RHDC
 RALEIGH HISTORIC
 DEVELOPMENT COMMISSION

CERTIFICATE OF APPROPRIATENESS PLACARD

620 W CABARRUS STREET

034-14-MW

SITE PLAN

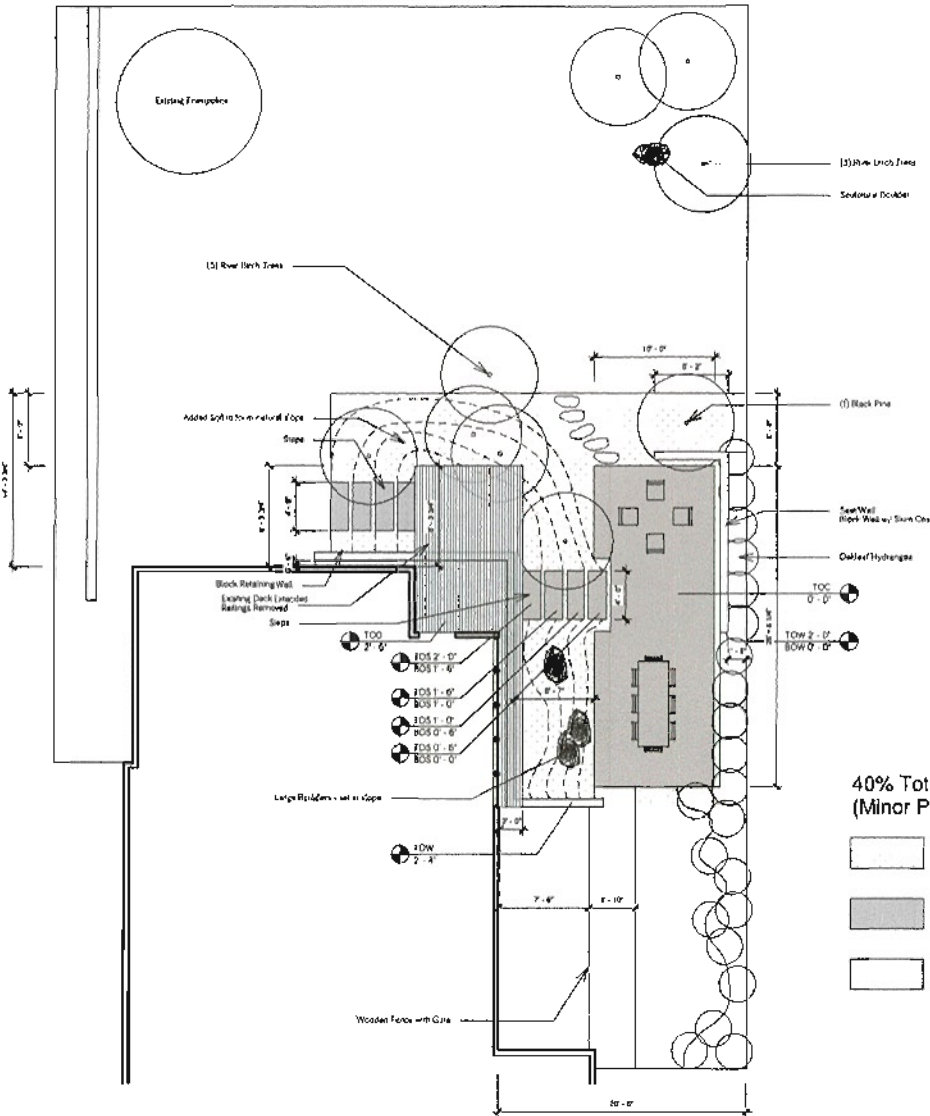
- What is the design of the fence screening the storage area?
- I've changed the working on the retaining wall to just wall, since there is nothing being retained at this point.
- I've removed items 8 & 12.b) because they reference items on the slope, they are included in the application going before the committee.

I'll get you something on the fence shortly. I can't remember if we were going with a tight vertical slat (as it appears in our materials sample pic) or ones with spaces.

Per 4/3/14 Phone Conv.
fence will be tight stats w/ square
top as shown in sample materials photo.
TGT

To confirm in writing:
It will be tight(no space) vertical slats with a flat top.
Matthew
